SPECIAL CAP MEETING – 19 JUNE 2024**ITEM 11.1**

DEVELOPMENT NO.:	21031284
APPLICANT:	PC Infrastructure Pty Ltd
ADDRESS:	160 LONGWOOD RD HEATHFIELD SA 5153 CT 6003/528
NATURE OF DEVELOPMENT:	24 hour retail fuel outlet with associated canopy, car cleaning & dog wash facilities, 70,000L underground fuel storage tank, pylon advertising sign (maximum height 7m), combined fence & retaining walls, retaining walls, car parking & landscaping (Amended Proposal)
ZONING INFORMATION:	Zones: <ul style="list-style-type: none"> • Rural Neighbourhood Subzones: <ul style="list-style-type: none"> • Adelaide Hills Overlays: <ul style="list-style-type: none"> • Hazards (Bushfire - High Risk) • Hazards (Flooding - Evidence Required) • Mount Lofty Ranges Water Supply Catchment (Area 2) • Native Vegetation • Prescribed Wells Area • Regulated and Significant Tree
LODGEMENT DATE:	1 February 2022
RELEVANT AUTHORITY:	Assessment Panel at Adelaide Hills Council
PLANNING & DESIGN CODE VERSION:	2022.1

DETAILED DESCRIPTION OF COMPROMISE PROPOSAL:

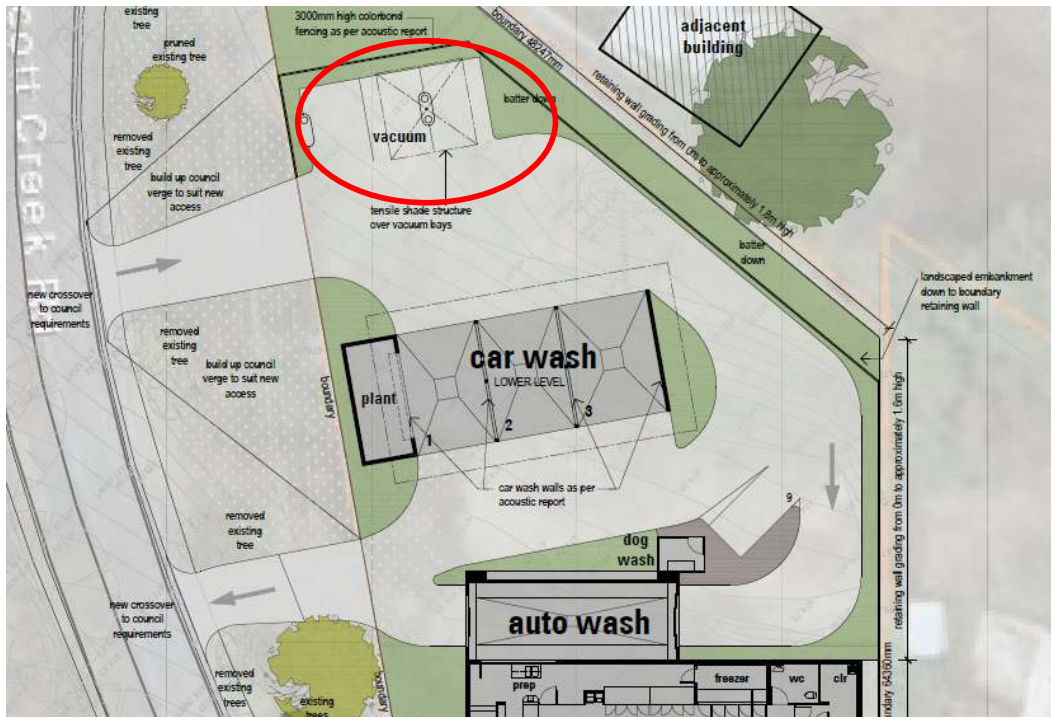
1. Removal of the manual car wash and plant room;

Location of manual car wash on previously refused proposal

Removal of manual car wash on compromise proposal

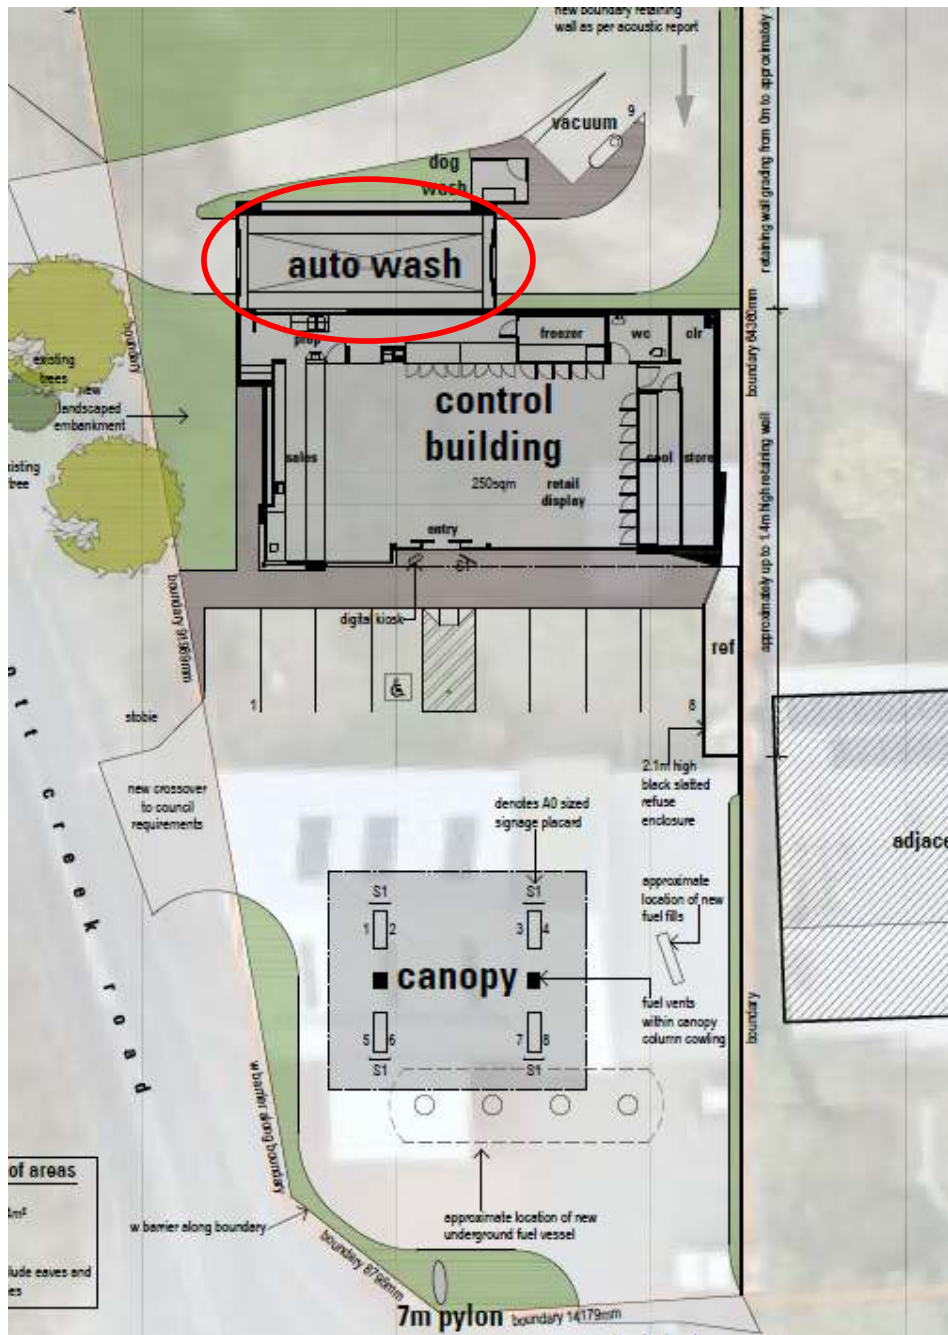
2. A reduction of vacuum bays from three to one and relocation of the vacuum bay adjacent to the automatic car wash;

Location of vacuum bays on previously refused proposal

Relocated vacuum bay on compromise proposal

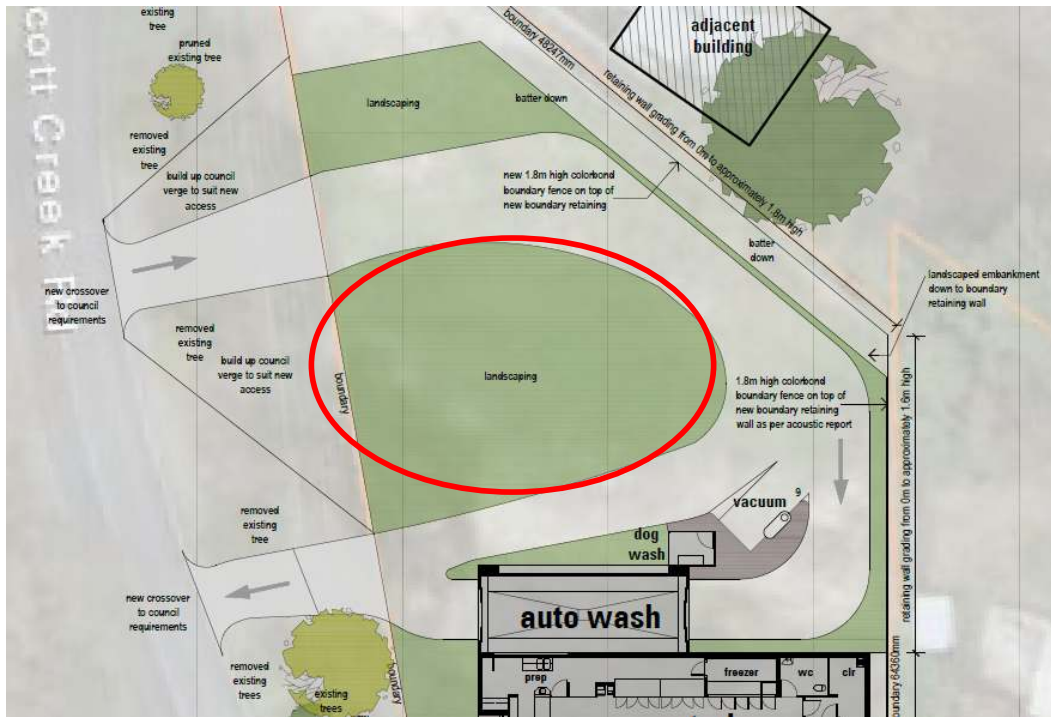
- 3. The automatic car wash has been reduced from a 24 hour operation to 7am to 10pm;

Location of car wash proposed to have reduced operation hours

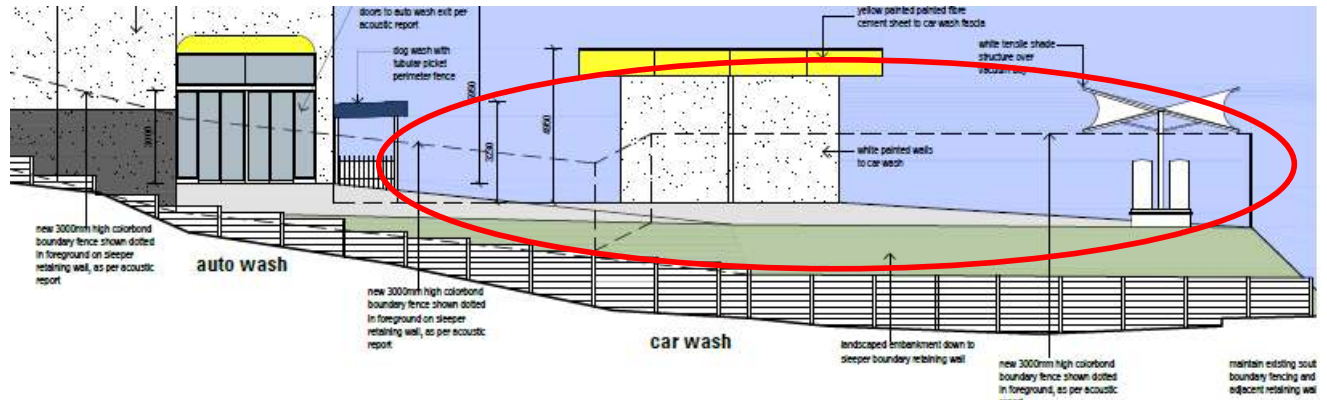
- 4. An increase of area identified for landscaping due to the removal of the manual car wash; and landscaped batter down to the rear retaining wall.

Increased area available for landscaping in compromise proposal

- 5. Removal of a three metre high acoustic fence adjacent the southern and south-western boundary; and addition of 1.8m high fence on top of retaining wall (maximum height 1.8m).

Area of acoustic fence which is proposed to be removed

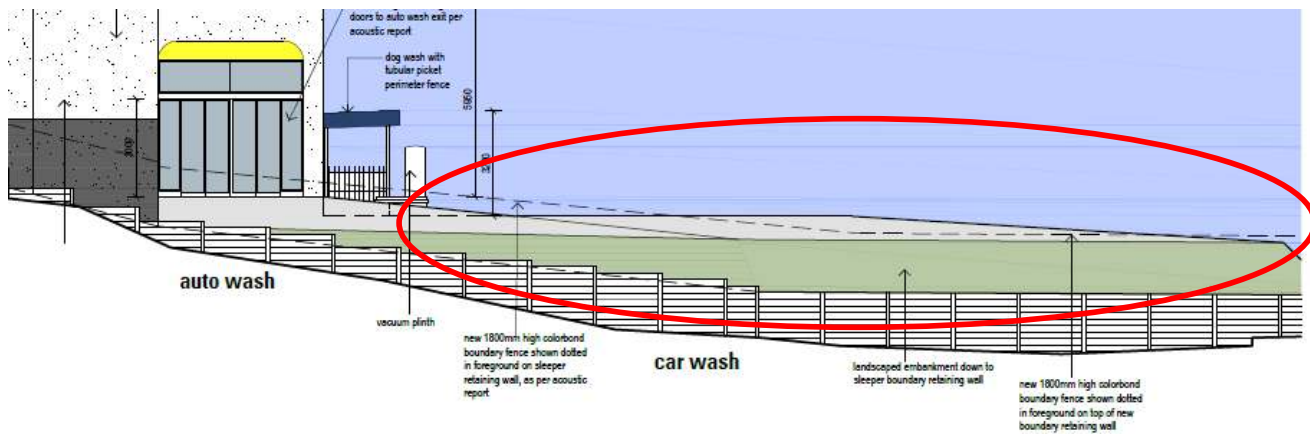
- Reduction of the three metre high acoustic fence to 1.8m on the western boundary; except in the location forward of the control building where portion of the fence will transition in height from 3m to 1.8m on top of retaining walls.

Location of three metre high acoustic fence on western boundary on previously refused proposal

New 1.8m high colorbond fence on western boundary on compromise plans

Figure 2: Acoustic barrier locations

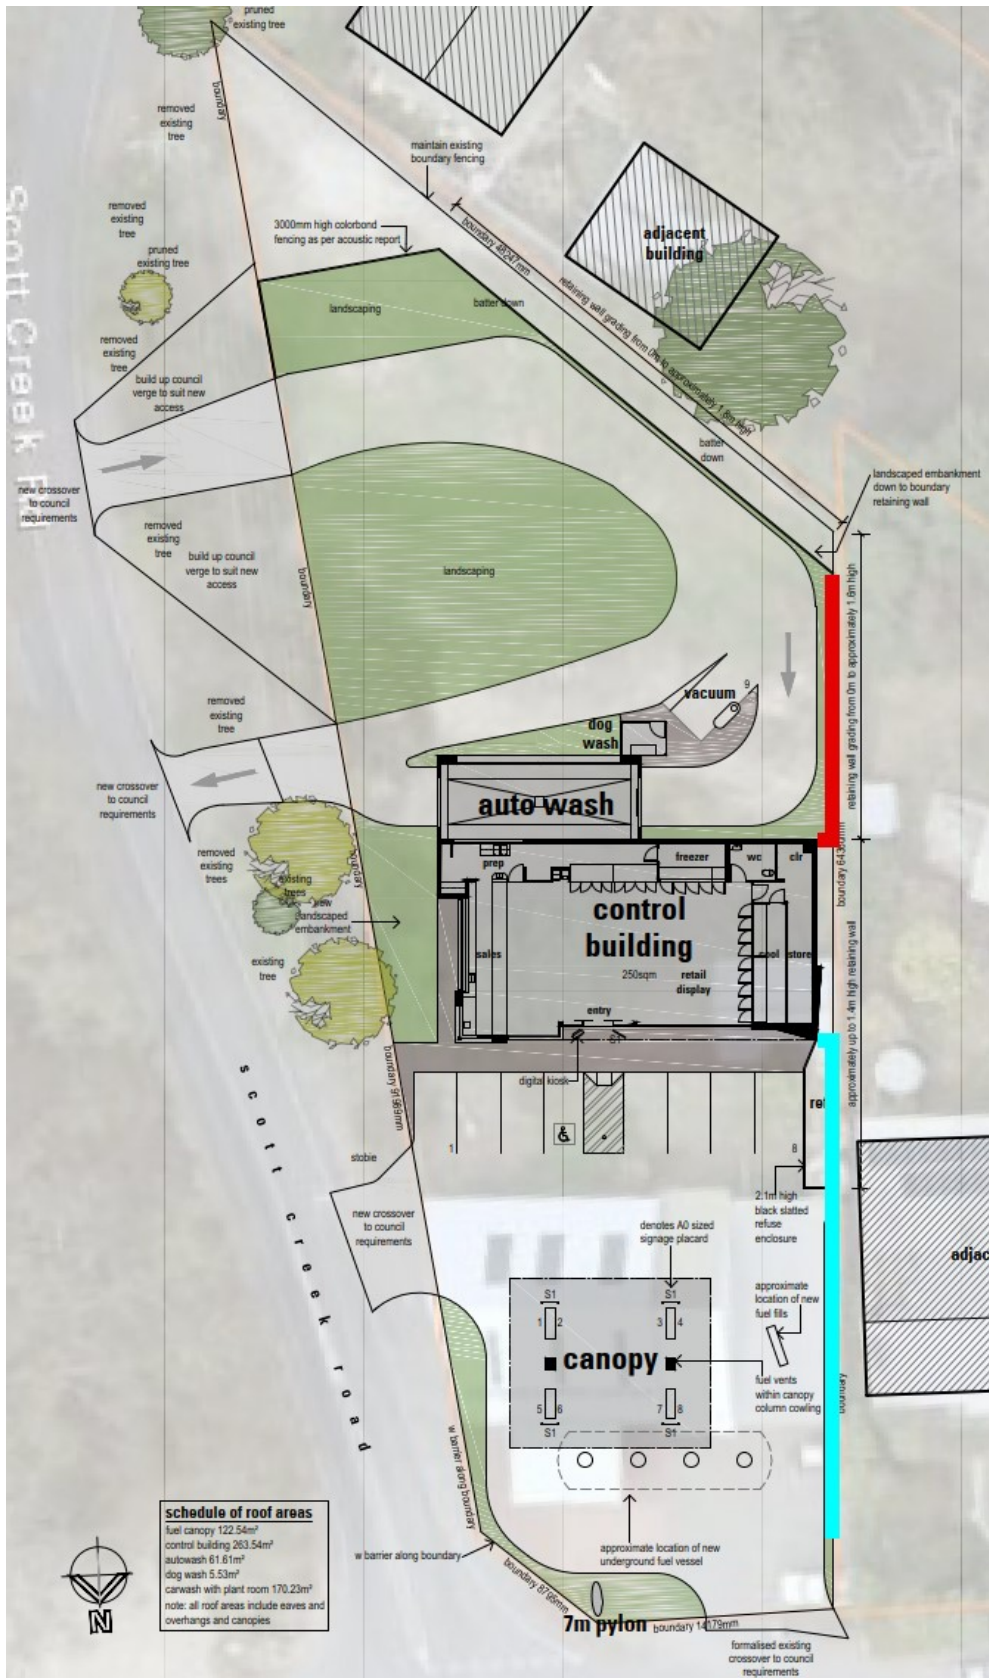
- Construct boundary fences for the extents shown as **CYAN** and **RED** in Figure 2.
 - The fence shown as **CYAN** should be at least 3m tall. If required, this fence can utilise a cantilevered construction, provided the overall height above ground level is maintained.

- The fence shown as **RED** should be at least 1.8m tall.
 - All fences should be constructed from a solid material such as 0.35 BMT sheet steel (*Colorbond* or similar).

- All heights provided are from the top of any retaining walls on the site boundary.
 - All fences should be sealed airtight at all junctions, including at the ground, joins to other fences, and joins to the building.

Figure 3: Mechanical plant location and treatment extent.

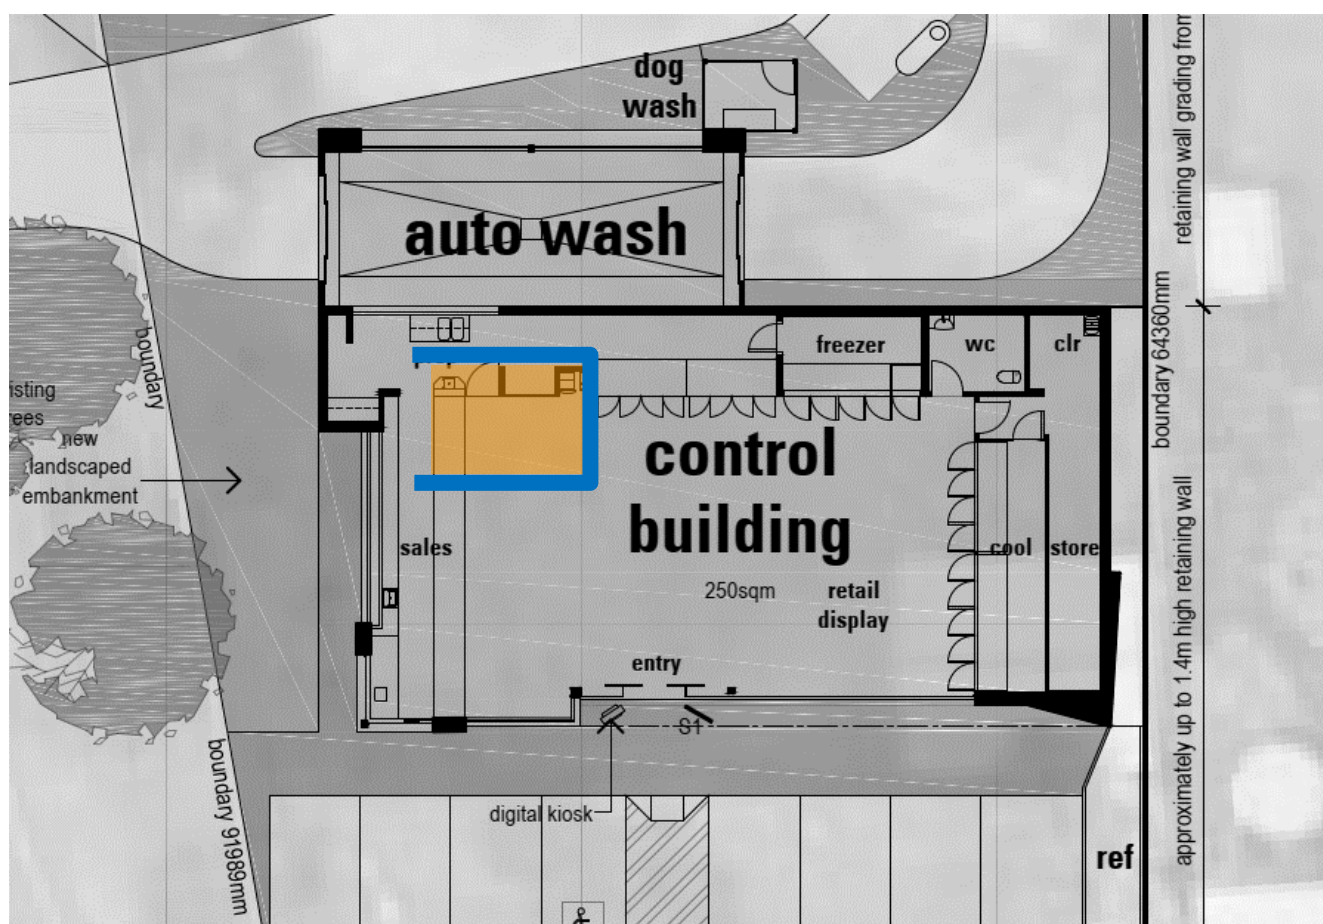
- Incorporate an in-line attenuator to the discharge side of any significant exhaust fans if present.
- Locate the rooftop mechanical plant within the area shaded in **ORANGE** in Figure 3.
- For the extent shown as **BLUE** in Figure 3, construct a solid screen around the rooftop mechanical plant units, which extends to a height of at least 0.5m above the tallest unit. A suitable material is 0.35 BMT sheet steel (*Colorbond* or similar). Ensure that the side facing Scott Creek Road is acoustically open with either no screening or with a standard open louvre construction.
- Install acoustic absorption, such as 50mm thick insulation with a minimum density of 32 kg/m³, to the full extent of the mechanical plant side of the screen. The absorption material should be installed in accordance with Detail 2.
